**RE: Peer Review Response – Preliminary Noise Study
2809 Townline Road, Twp of Puslinch ON (25021383)**

**Re: Review of Peer Review Response Letter
 Preliminary Noise Study
 2809 Townline Road
 Puslinch, Ontario
 VCL File: 123-0460**

Excess Levels – Night-time
Plan A

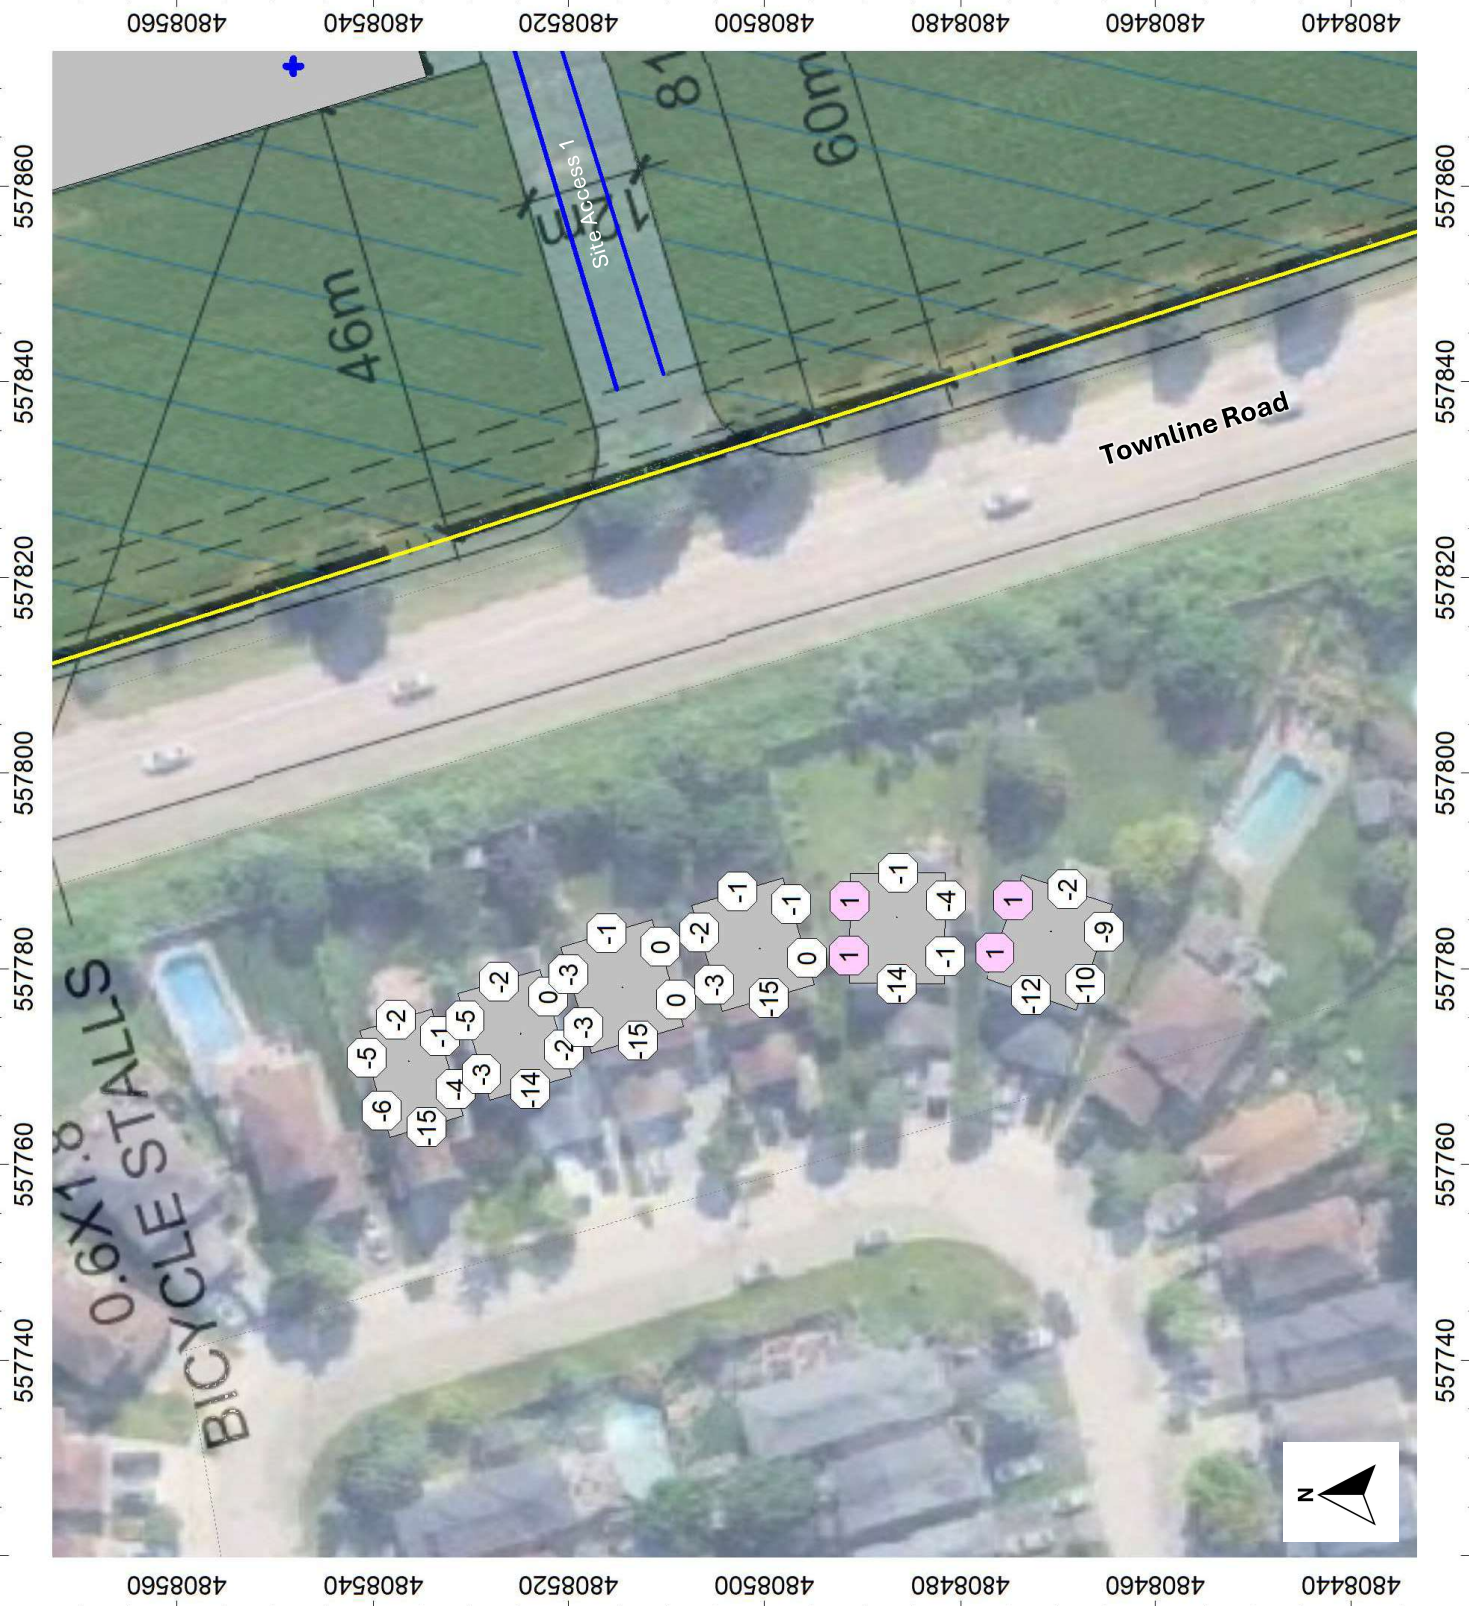
The ambient calculations appear to have been done on the rear (east facing) facades of the dwellings. This likely is not the worst-case location. It is likely that the north-facing facades receive similar worst-case noise levels but a lower ambient sound level/guideline limit. Additional assessment is requested.

Based on a revised analysis with Building Evaluations, ambient sound levels along the north/south facades drop by 1 to 4 dBA in comparison to the east façade (facing the Project) for the various houses in proximity to Site Access 1 (worst-case impacts related to ambient noise). With an associated drop in facility noise impacts (0 to 5 dBA), a 1 dBA excess is predicted at the worst-case home near Site Access 1 (see attached figures).
